Action Required For Identifying the Recalled Bendix® SC-3™ Single Check Valve

Identifying Bendix® SC-3™ Single Check Valves Covered in this Field Action

Figure 1 - SC-3 Single Check Valve Retainer

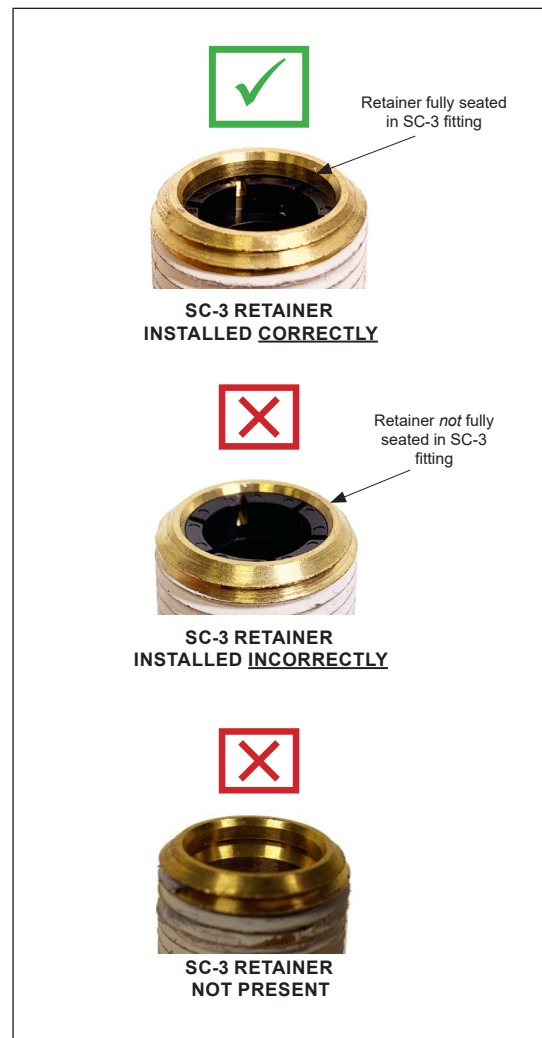
2. See Figures 1 and 2. Inspect the Bendix® SC-3™ single check valve retainer. If the retainer is fully seated, it is correctly installed and not affected by this recall campaign. If the retainer is not fully seated, or is missing, damaged, or the shuttle or the retainer are missing or fractured, the SC-3 single check valve falls within the recall parameters. The SC-3 single check valve needs to be replaced. If the shuttle or the retainer are missing (not located in the SC-3 fitting nor in the supply port of the Bendix® SR-7® spring brake modulating valve) or fractured, the SR-7 spring brake modulating valve will need to be replaced as well.

Figure 3 - SR-7 Spring Brake Modulating Valve Date Code Interpretation

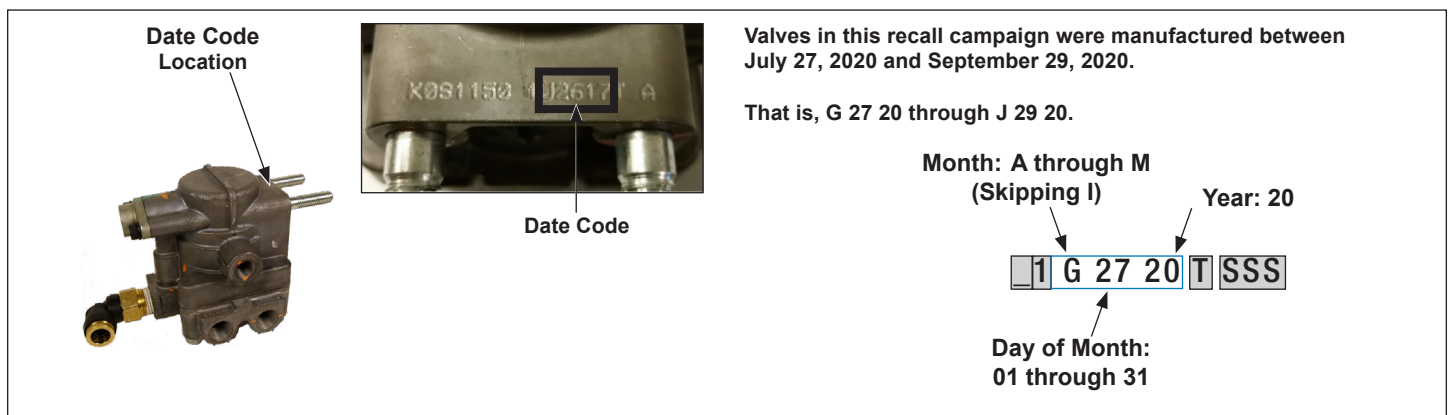
1. See Figure 3. A potentially defective SC-3 single check valve that was purchased as part of an assembly with an SR-7 spring brake modulating valve can be identified by the date code on the SR-7 spring brake modulating valve. If the SR-7 spring brake modulating valve has a date code that is any date between, and inclusive of, 7/27/20 and 9/29/20, the SC-3 single check valve falls within the recall parameters. The SC-3 single check valve needs to be replaced.

See Figure 3. A date code is stamped (not cast) on the SR-7 spring brake modulating valve body housing. Locate the date code – removing the paint coating if necessary – to read the code. Disregard the codes shown in gray in Figure 3. The portion of the date code that determines the date of manufacture is highlighted and can be interpreted as follows:

- The first field is the month (A= January, B = February, etc. – excluding the letter I – so that J= September, and so on),
- The next two fields are the day of the month (e.g. 01 = 1st); and
- The next two fields are the year (e.g. 20= 2020)
